MEETING NOTES

PROJECT: Development at 57 JFK St.

AGENDA: Electrical Service- SC Station Vault- review of revised layouts with Eversource.

1 LOWER LEVEL (BELOW GRADE)
SCALE: 1/4" = 1'-0"

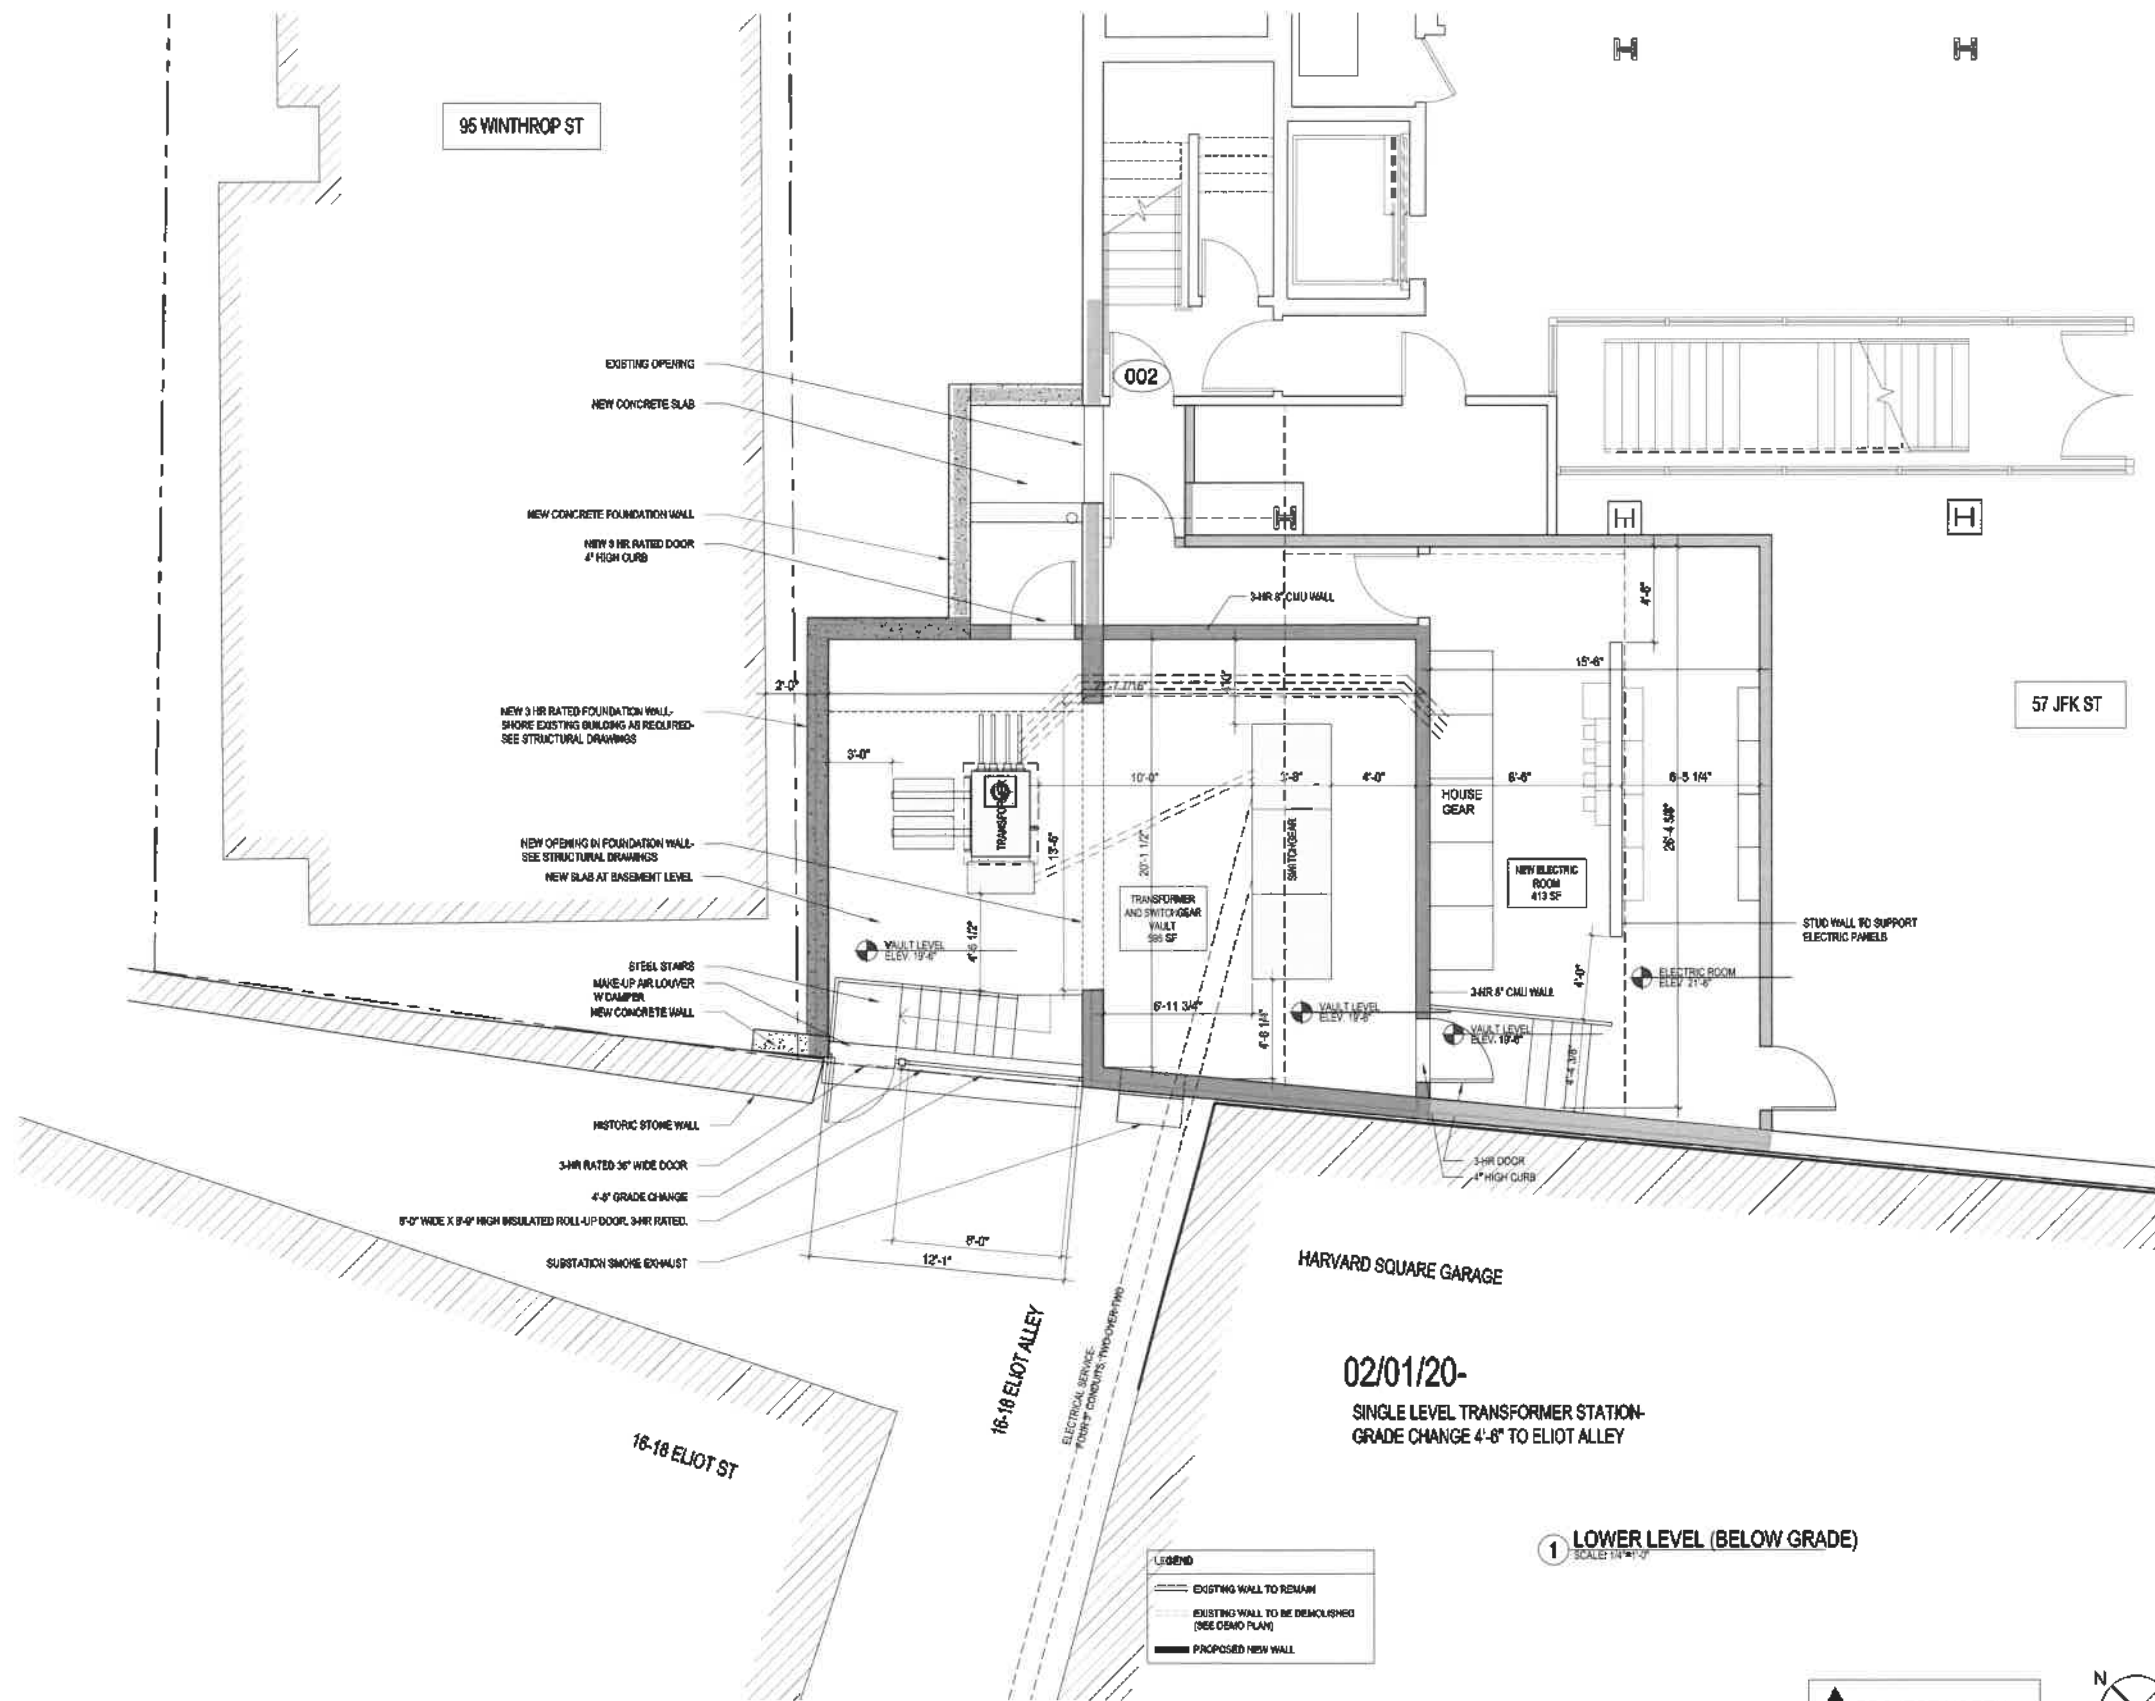
Eversource verbally approved the schematic design with the following comments:

1. The exterior roll-up door to have a minimum opening size 8'-0" wide x 8'-9" high, (because the Switchgear is installed standing upright).
2. Stairs next to the roll-up door to be removable.

3. Transformer and Switchgear could be installed with a forklift. Transformer may be able to be installed without support from steel above- Eversource to review installation with their install group and advise design team.

4. 4" curb required at doorways to contain equipment fluid.
5. Transformer and Switchgear to be on 4" high pads that extend 4" beyond the equipment. Structural column next to Switchgear to be kept clear of the pad.

6. Two means of cooling Vault reviewed- air conditioning vs. ventilation. Owner expressed preference for ventilation. Design team to look at placing vent on roof of Vault in Alley. Eversource said heating unit would still be required for winter.

7. A ground bar will run around room and over doors.

8. Vault to have two wall outlets: one NON-GFCI and one GFCI.
9. Eversource prefer no sprinklers but will allow sprinklers if required by building code. Sprinklers shall be double, interlocked, pre-action sprinkler system. Wet-pipe sprinklers and dry-action sprinklers are not allowed.
10. Eversource confirmed in email, 1/17, that 3HR rated enclosure required- no exceptions given if vault is sprinklered.
11. Eversource to forward to specs of Indoor Vaults and sizes of Switchgear and Transformers to PQA/ Zade. *(received 1/16)*.
